Cumberland County Subdivision and Land Development Review Report

Municipality:	<u>Carlisle</u>	Surveyor/ Engineer:	<u>Stonefield Engineering</u>	Owner/ Developer:	<u>Carlisle Capital</u>
Plat Title:	<u>7-Eleven</u>				
Plat Status:	<u>Preliminary/Final</u>	Plat Type:	<u>Land Development</u>		
# of New Lots:	<u>0</u>	# of New Dwelling Units:	<u>0</u>	New Acreage Subdivided/Developed:	<u>0</u>
				Total Tract Acreage:	<u>.79</u>
Zoning District:	<u>C-3</u>	Proposed Land Use:	<u>Convenience Store w/Gas</u>		
Date Received:	<u>6/9/2020</u>	County Review:	<u>6/19/2020</u>	Reviewed by:	<u>SH</u>
				Checked by:	<u></u>

**PROPOSED CONVENIENCE STORE
WITH FUEL SALES**

PARCEL ID: 51-23-0598-026
1003 SOUTH HANOVER STREET
BOROUGH OF CARLISLE
CUMBERLAND COUNTY, PENNSYLVANIA

TITLE:
COVER SHEET

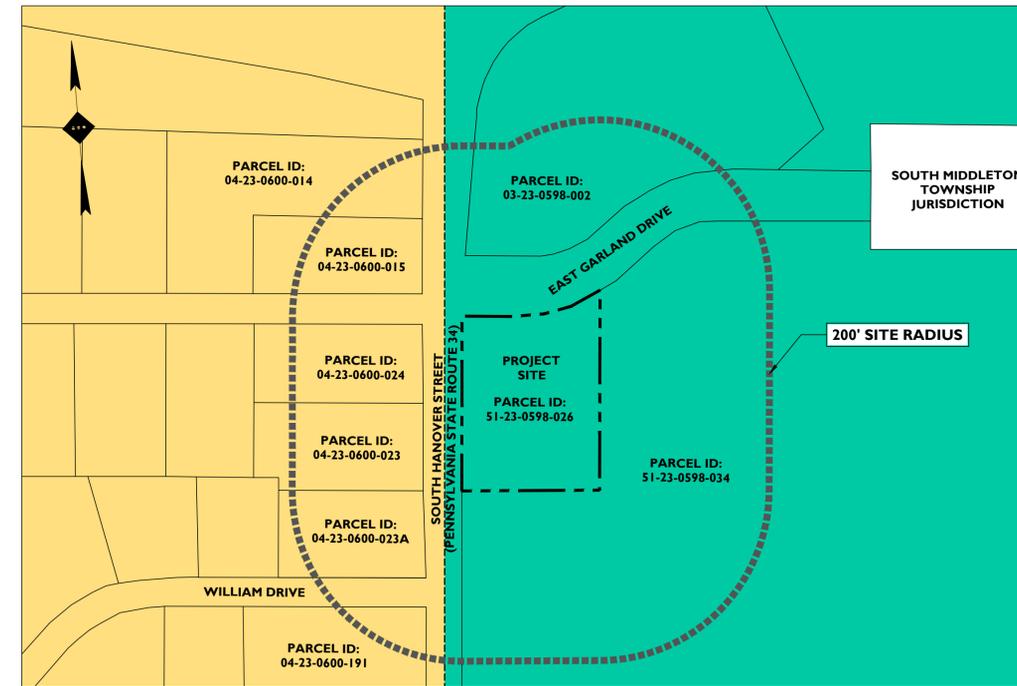
8. The Approval Block for the Cumberland County Planning Commission should indicate that the plan was reviewed by the Planning Commission. In addition, the Director of Planning will provide a signature. The line for a secretary signature can be removed (SLDO 226-20.A.6).

9. The cover sheet should include a list of all waivers, variances and Special Exception approvals (SLDO 226-20.A.7.E).
10. The plan should address the Pennsylvania DEP Sewage Planning requirements (SLDO 226-20.B).
